**U.S. Army Corps  
of Engineers**  
Engineering and Support  
Center, Huntsville

## **Fire Station #5**

**Building 2620  
Fort Riley, KS**

**POTR – Phase 2  
Project No 54914**

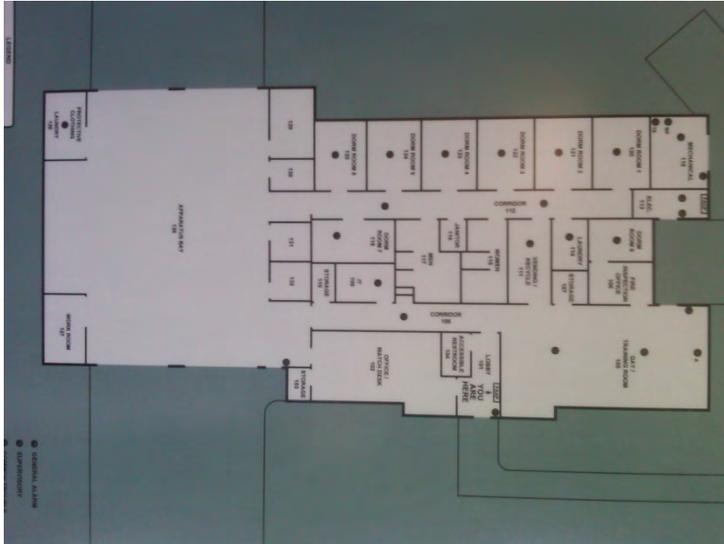
- Bay doors – when it rains, all the rain comes into the apparatus bay. There is no trench drains at the doors. Problem with roll-up doors is it is very difficult to get a good seal due to the auto reverse function.

- Fire proof caulking was not provided around piping in the fire wall.
- Front windows are not operable. Bedrooms typically have operable windows.
- 2 bays are inadequate. Need at least 3 bays. There is no way to expand the facility at this time.

- There is not enough storage space for the inventory of items stored. They have a shed outside for additional storage.
- This facility does not have a fitness room. What had originally been designated as the fitness room is the small inner room that was opened up to create the Chief's Office. The space as originally designed was too small and was not practical for the function.

Figure 1 – Condensing Unit 1

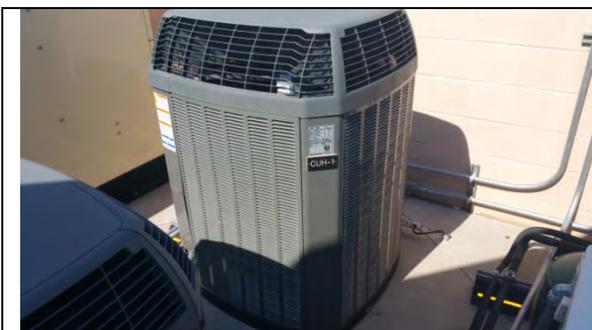
- Range Hood – The range hood in the kitchen is improperly configured and allows extreme amounts of infiltration during both the heating and cooling season.
- Cooling/Heating – Facility users reported both cooling and heating issues during the extremes of the season. During peak humidity events, piping above the ceiling begins to sweat and condensation builds up in the light fixtures. The sleeping quarters are provided with independent ductless split systems.

Figure 8 – Vehicle Exhaust Manifold

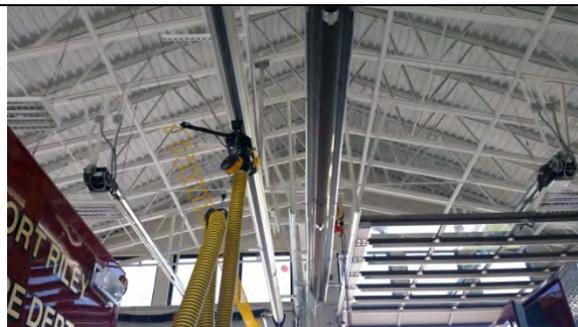
- Vehicle Exhaust System – The vehicle exhaust system is only partially operational and no longer in compliance with NFPA guidelines.
